DATE: April 2, 2025
SUBJECT: **Detailed Note No. 031 – Red Chris Block Cave Production Phase
Detailed Response to THREAT Technical Memorandum on the Red Chris Block Cave
Feasibility Study Numerical Modelling Report**

TECHNICAL MEMORANDUM

Date: 28 March 2025
To: Ian Austen and Aleksander Purba, Newmont
From: Miguel Fuenzalida and Ehsan Ghazvinian
Re: Responses to Subsidence Report
Ref: 2-5273-02:25TM13

Figure 1 Base case, fracture limit contour defined as 0.5% strain limit.

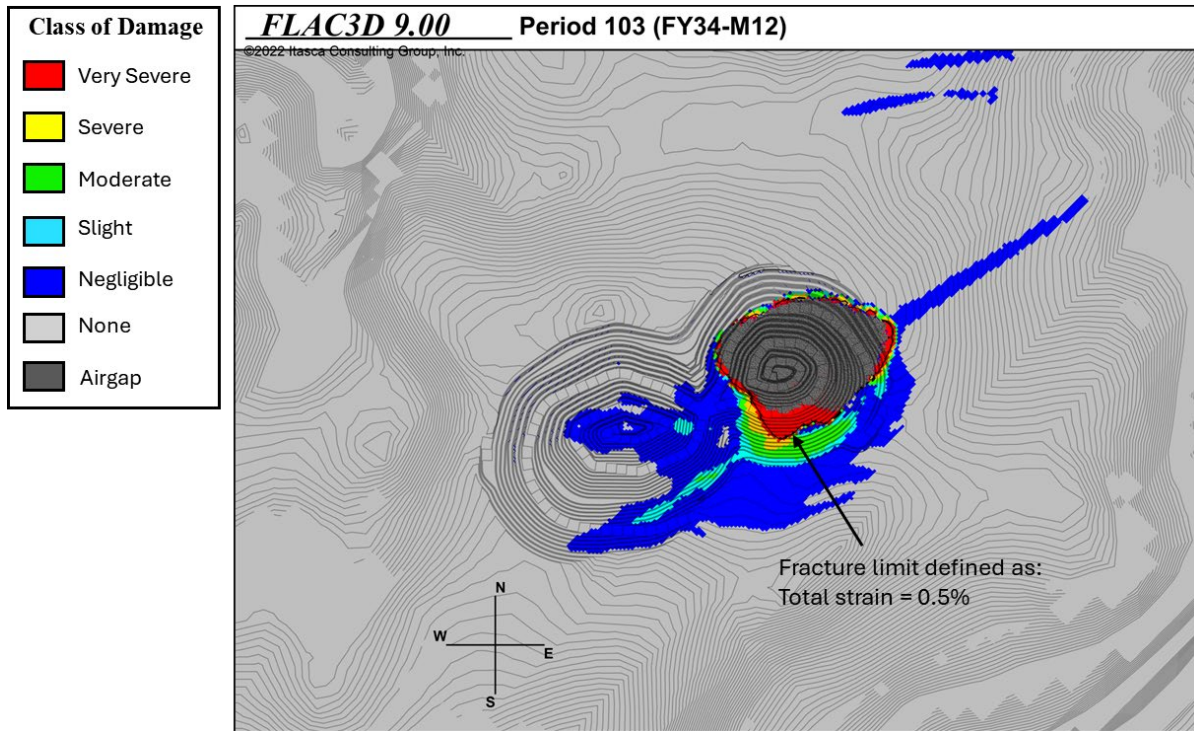
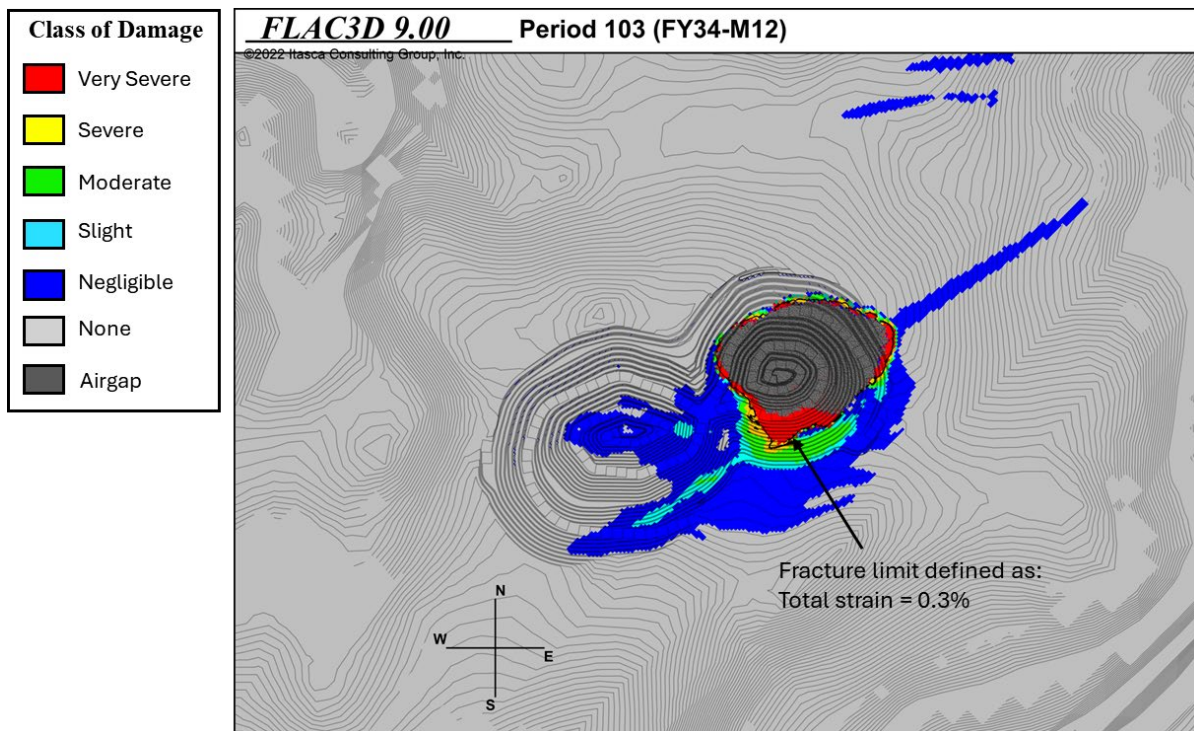
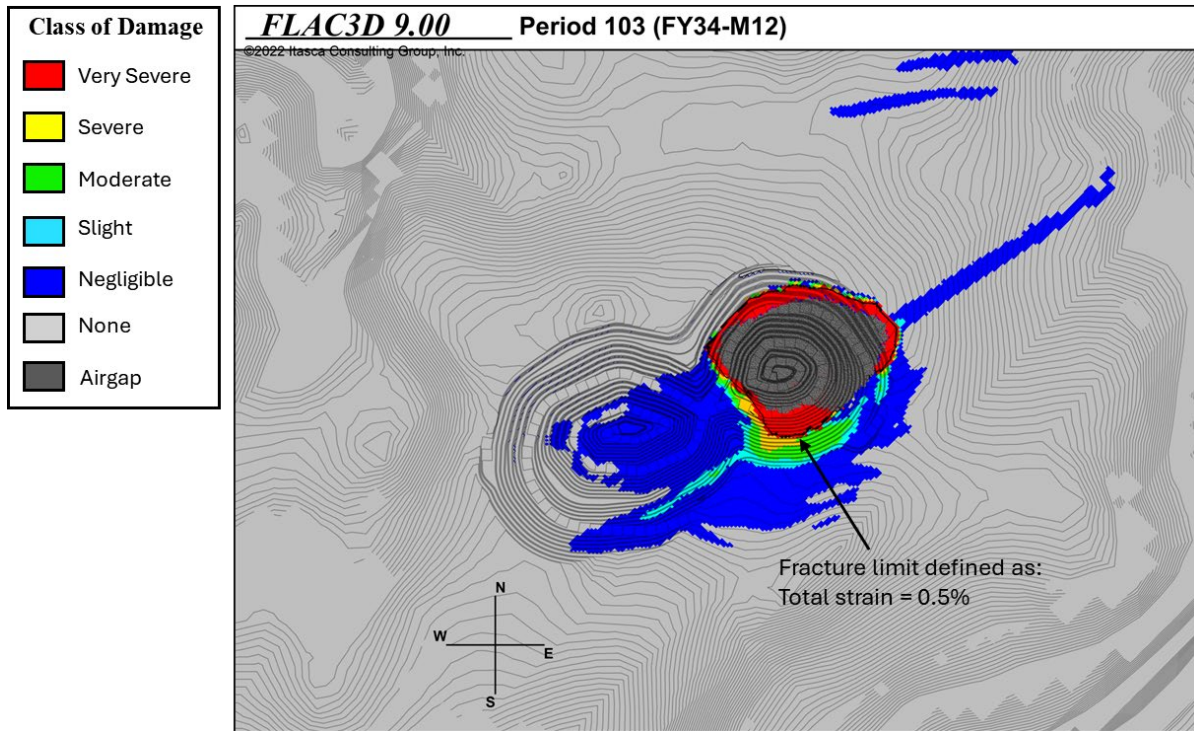
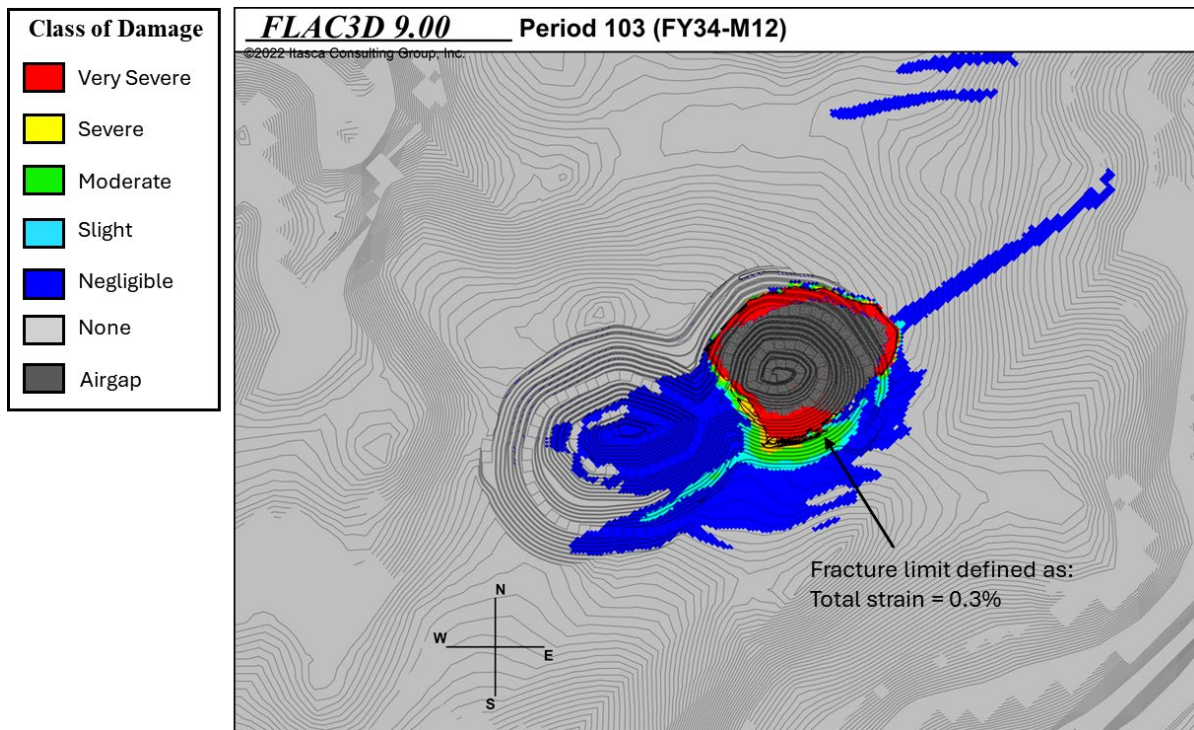
CLARIFICATION/ACTION (IMPORTANT): Based on this, we are asking for iso-surfaces corresponding to a larger range of total strain (0.3% to 0.5%) to understand the long-term impacts of cave-induced subsidence (i.e., damage does not remain constant over time, as demonstrated by satellite images of Palabora cave-induced pit failure).

In response to reviewer comments, and as requested at the March 5, 2025, meeting, ITASCA has generated additional iso-surfaces and plan views using a more conservative threshold of 0.3% total strain for the base and sensitivity cases. The base case assumes a higher rock modulus (stiffer, harder rock) and the sensitivity case assumes a lower rock modulus (more compressible, softer rock). The fracture limit associated with the base case at a 0.5% total strain threshold was presented in the Amendment Application. The differences between the 0.3% and 0.5% limits are minimal, as expected (see Figures 1–4). The 'Class of Damage' scale included in the iso-surfaces corresponds to the Harrison damage classifications presented on page 58 and 59 of ITASCA (2023).

Figure 5 *Example of stress distribution in and around the IMZ using FLAC axisymmetric models. Stresses are profiled along a line radiating from the drawpoint center into the surrounding stagnant material at an elevation 25 m above the model base (from Pierce, 2010).*

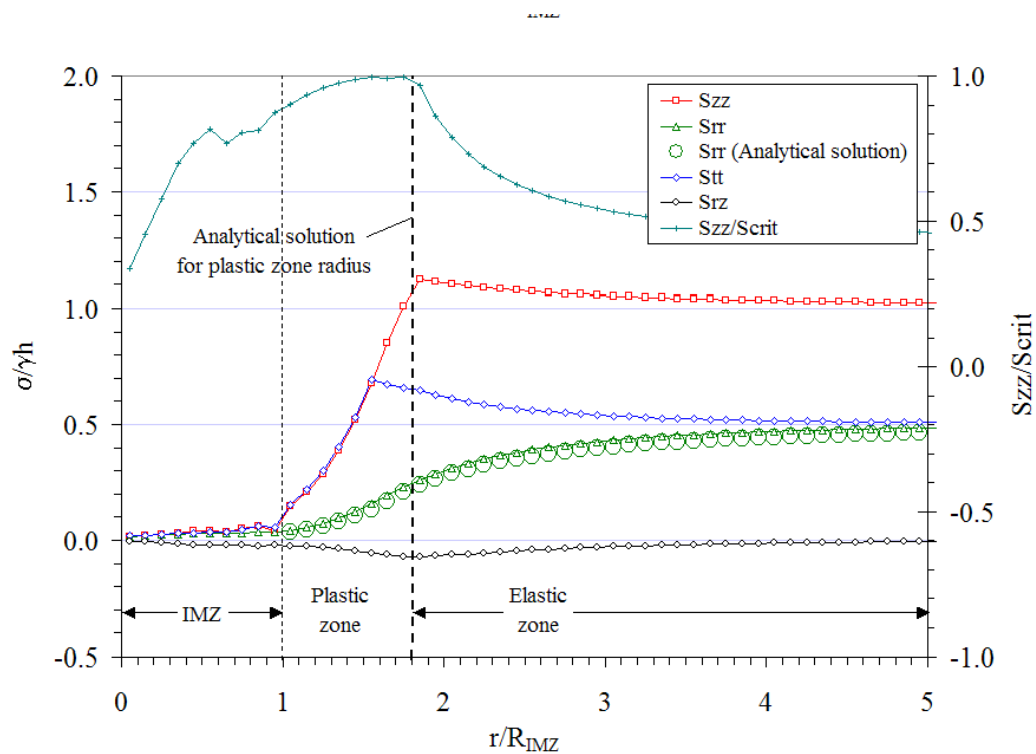
CLARIFICATION: Was a decision made not to display the principal stress contours in the mobilised zone? What is the reason behind the apparent abrupt changes in principal stress magnitudes and direction at the contact with the mobilised zone?

There is no specific reason why principal stress contours are not shown within the mobilized zone. ITASCA determined that showing caved rock displacements due to draw was more informative than displaying lower stress values within this region.

The changes in principal stress inside and around the movement zone align with expected behavior. Figure 5 presents the stress distribution around the movement zone at varying distances.

Figure 6 CDFs to develop bin classes for use in defining in-situ fragmentation (Golder, 2022).

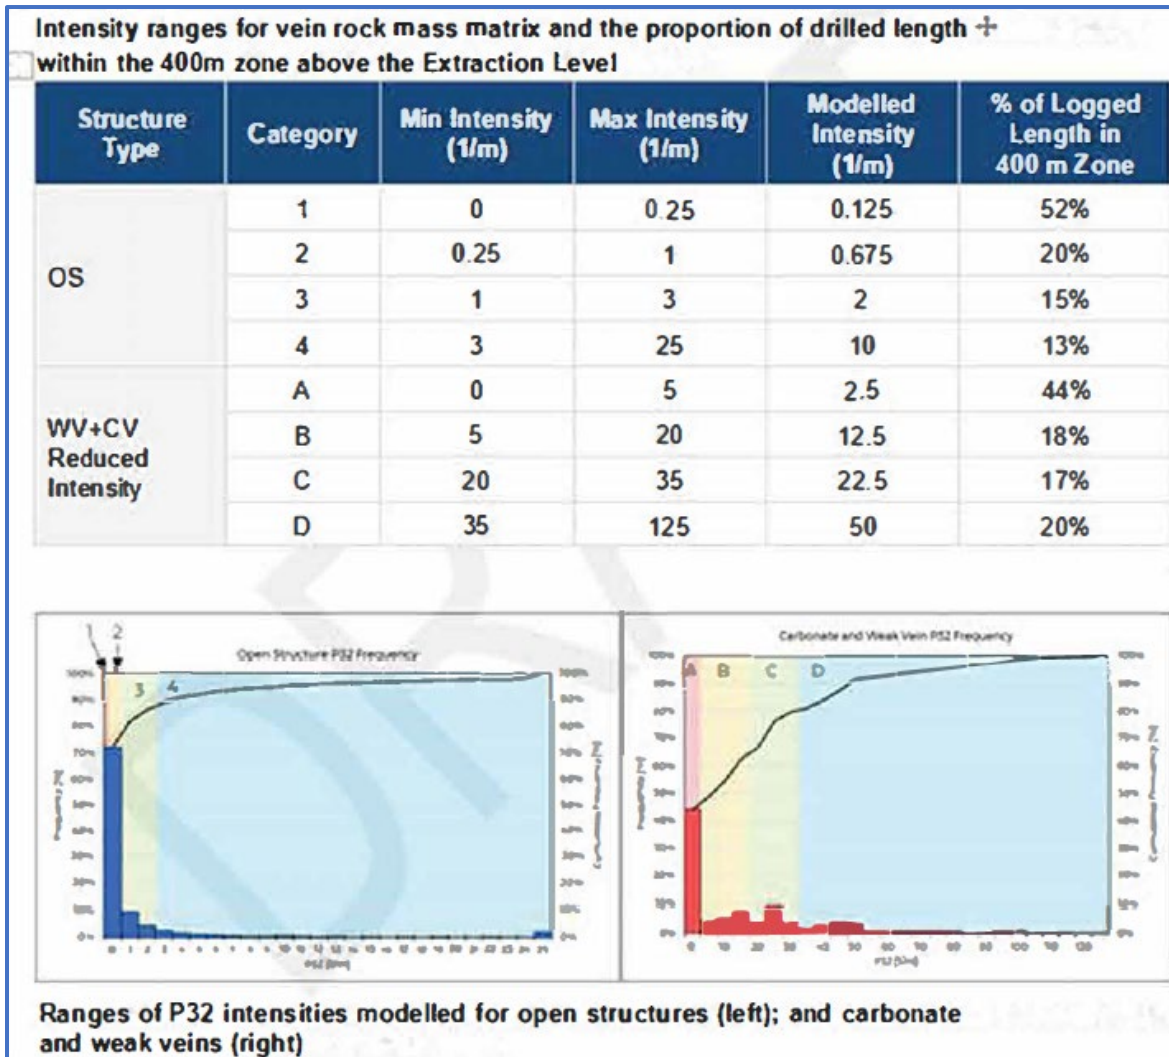
The “matrix” shown in Figure 4 of the Subsidence Report adopts arbitrary ranges for P32 (open structures) and P32 (veins). For example, the rows and columns of the “matrix” follow two different scales with different rates of change between the bins. For example, in Figure 4 of the Subsidence Report, the P32 (open structures) lumps all values of P32 greater than 2 m⁻¹ into a single bin. Figure 5 of the Subsidence Report shows that the P32 (open structures) bin [2, 3 m⁻¹] contains about 12% of the data, while the bin [3, 4 m⁻¹] contains 10% of the data. Figure 5 does not include data less than P32 of 1 m⁻¹, so it is unclear how the bins for P32 of 0.675 m⁻¹ and 0.125 m⁻¹ were established in Figure 4.

The CDFs were divided into classes based on where rates of change occur along the CDF curve. Where the change along the curve was rapid, the bins were smaller and where the change along the curve was less steep the bins were larger. Please note that bins of 0.675 and 0.125 both fall into class 1 and would not be meaningful to adjust further. The bin classes were based on the CDFs in Figure 6.

Figure 7 **The DFN model set-up (Golder, 2021).**

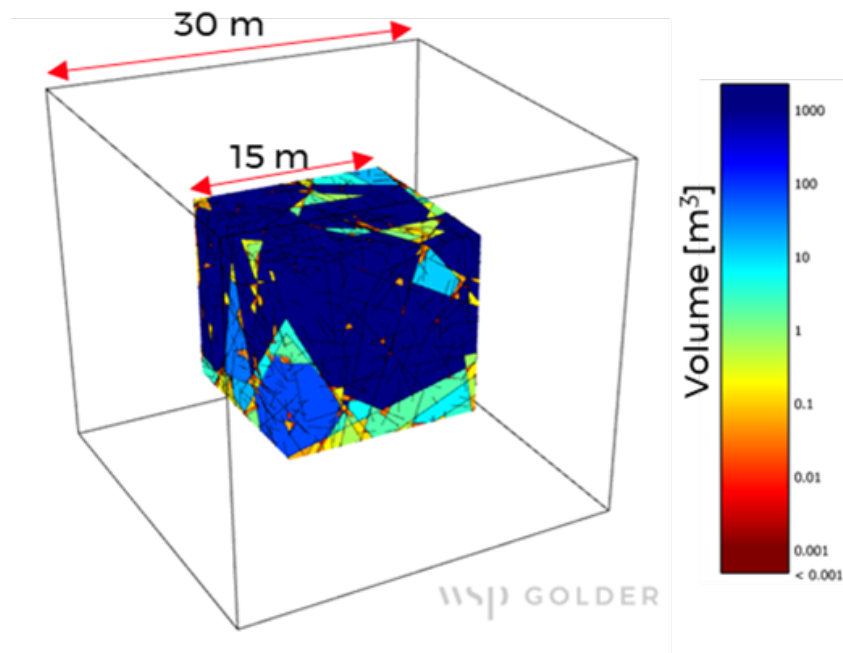
Similarly, the rock mass category model shown in Figure 6 of the Subsidence report adopts somewhat arbitrary bins. How can the DFN model detect blocks of 0.001 m³? That would mean a search region with an edge length of 0.33 mm. We understand this is not feasible in the block search algorithm of the DFN model. The minimum grid size used was likely 0.3 m (yielding a 0.027 m³).

In order to avoid edge effects of the DFN model due to generating fractures using centers and clipping on the outer region, a generation region is utilized that is typically a factor of two to three times large than the region of interest (the sampling region). The Sybil-Frac algorithm is computed on the smaller sampling region. In Red Chris case, a sampling region of 15m by 15m was used in order to match the size of a block modelling grid cell, and therefore, a generation region 30m by 30m by 30m was used to create the DFN. The Sybil-

Frac grid utilized was 150 x150 x150 cells meaning that each cell represents a volume of 0.1m by 0.1m by 0.1m or 0.001m³. The model set-up is illustrated in Figure 7.
